**TECHNICAL COMMITTEE ON THE
ONGOING MAJOR AND MEDIUM
IRRIGATION PROJECTS IN KERALA**

FINAL REPORT

KERALA STATE PLANNING BOARD

AUGUST 2018

Figure 2 Cut-off diagram of the Banasurasagar irrigation project

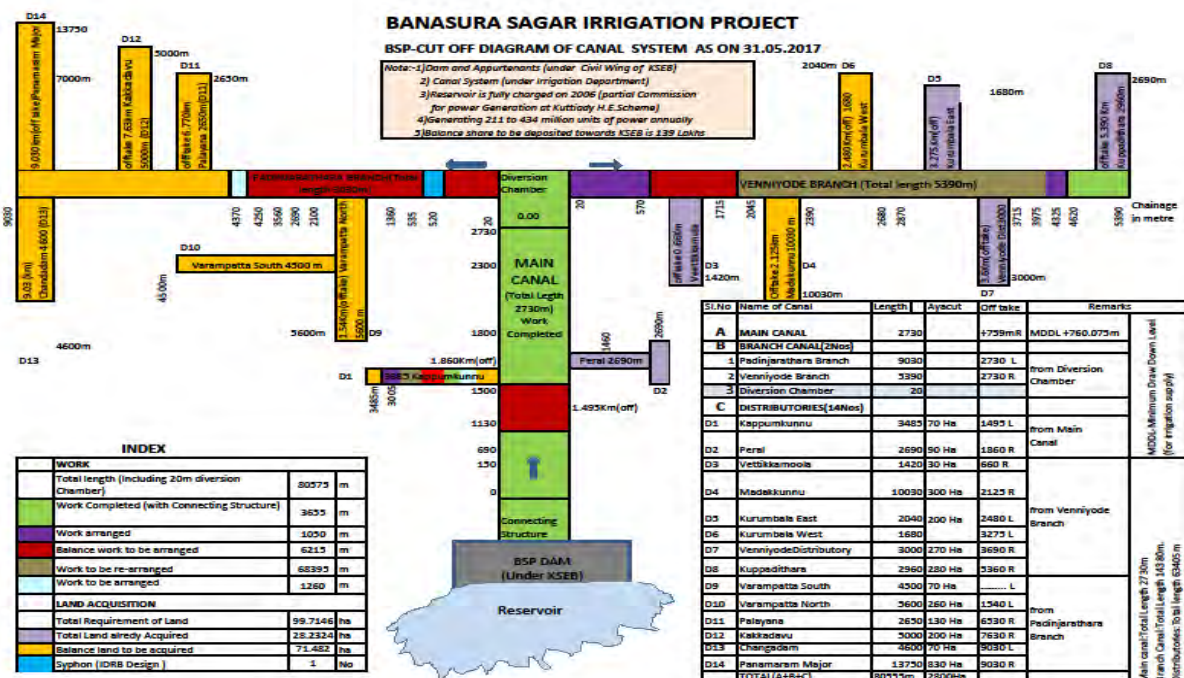
Work on the Padinjarathara branch canal has only been partially complete from 20 m (when the branch canal actually begins after diversion) till 4250 m (see Figure 2). The fully completed stretches within the branch canal are: (a) from 43.50 m till 174.60 m; (b) from 1486.40 m till 1536.90 m; and (c) from 1545.40 till 1561.40 m. This constitutes a total length of aqueducts of about 197.60 m. This apart, work on another 181.70 m has also been completed under cut and cover or flume (a) between 2093.60 m and 2185.30 m; and (b) between 2407.80 m and 2497.80 m. The rest of the work is largely in the nature of partial constructions of mass piers and trestle piers.

(a) The approval for the revised syphon-based design of the Padinjarathara branch canal needs to be urgently accorded by the IDRIB and the work has to be completed at the earliest.

(d) Between 20 m and 2100 m in the Padinjarathara branch canal, the department should explore the construction of maximum numbers of sluices to ensure that water can be diverted into the natural waterways on either sides.

Figure 4 Canal network with catchment area and paddy area, Banasurasagar irrigation project

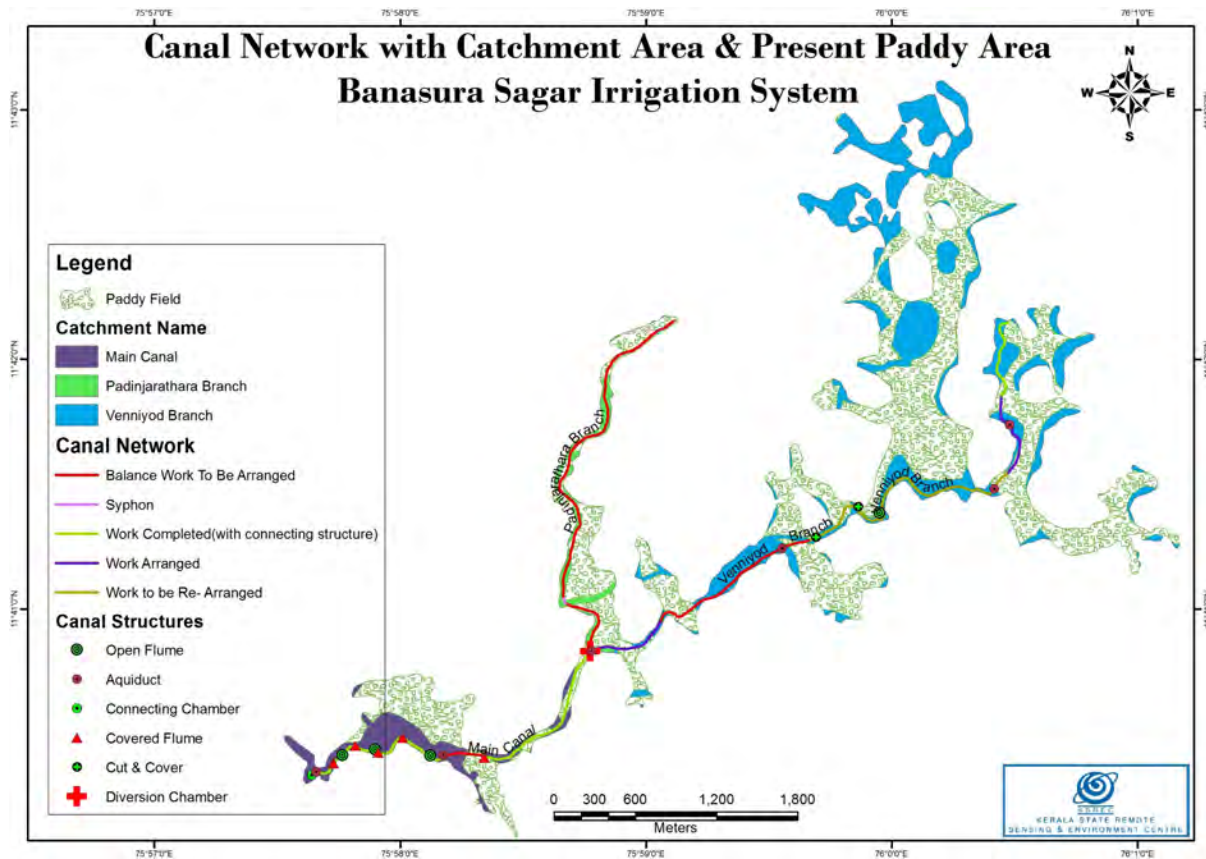
(b) Work on the Padinjarathara branch canal may be terminated at the site of the accident viz., at 2300 m. In our view, dismantling the partially constructed portions of the branch canal and completing construction of the branch canal up to 2690 m is an extremely complicated and difficult task to achieve. Moreover, our analysis of the command area in the Padinjarathara branch canal network shows that the area that could be irrigated is also likely to be small (see Figure 4).
